# Historical Affairs and Landmark Review Board

HALRB Case 17-23 (HP1700046)

A request by Richard and Christiana Cameron, owners of 3202 23<sup>rd</sup> Street North in the Maywood Neighborhood Historic District, to replace the cedar-shingle roof with asphalt shingles.

**TO:** HALRB  
**FROM:** John Liebertz, Historic Preservation Planner  
**DATE:** October 6, 2017  
**SUBJECT:** 3202 23<sup>rd</sup> Street North, Case 17-23, Maywood Historic District

Figure 1: The subject property is outlined in blue. The black dots represent a composition roof. A wood shingle roof would be represented by a small “x” or cross.  
Source: Sanborn Fire Insurance Maps, 1929.

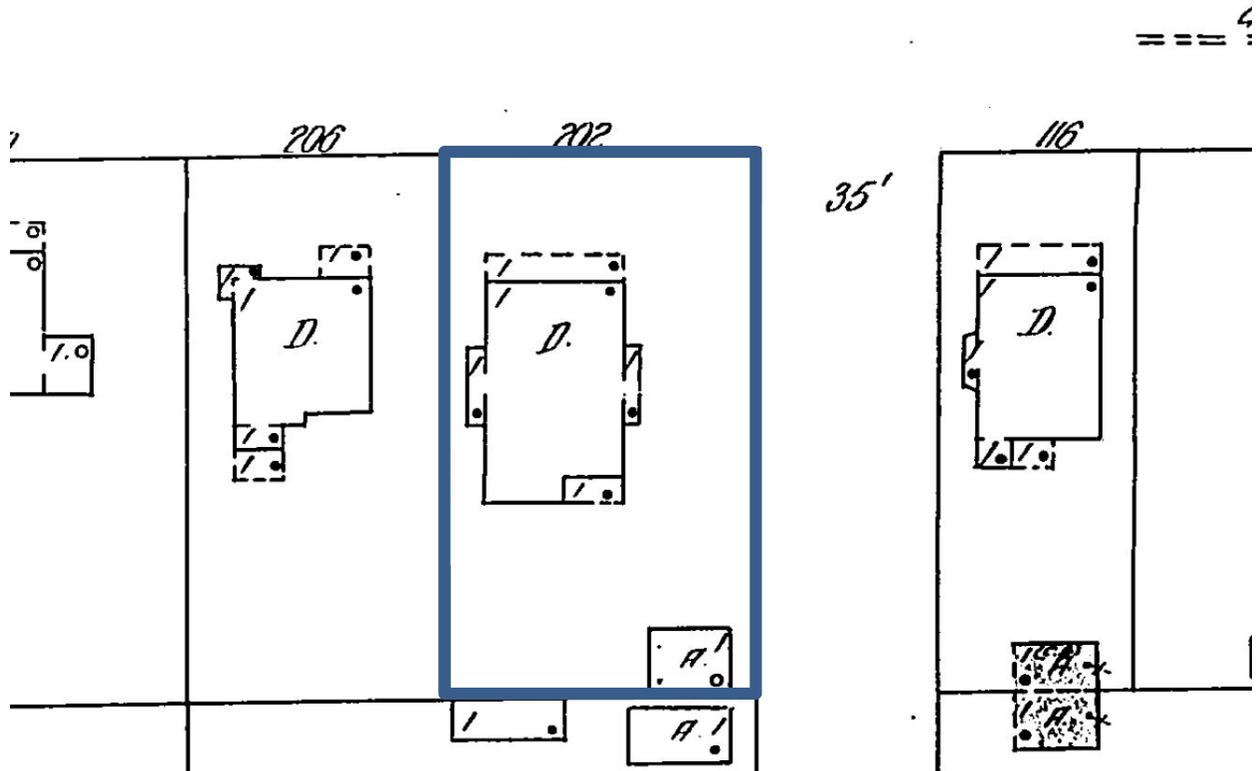
The HPP staff recommends approval of the subject application. Both asphalt shingle and cedar shingle roofs were typical of Craftsman-styled bungalows in the early-twentieth century. Staff reviewed the archival materials relating to the roof material of the subject dwelling. *Sanborn Fire Insurance Maps* from three different years (1929, 1936, and 1959) all note a composition roof and not wood shingles on the main dwelling. The proposed removal and replacement of the non-historic wood shingles with asphalt shingles more accurately represents the defining characteristics of this particular house. Therefore, the Historic Preservation staff recommends approval of the subject proposal as it complies with Chapter 5: Exterior Renovation of the *Maywood Design Guidelines*.
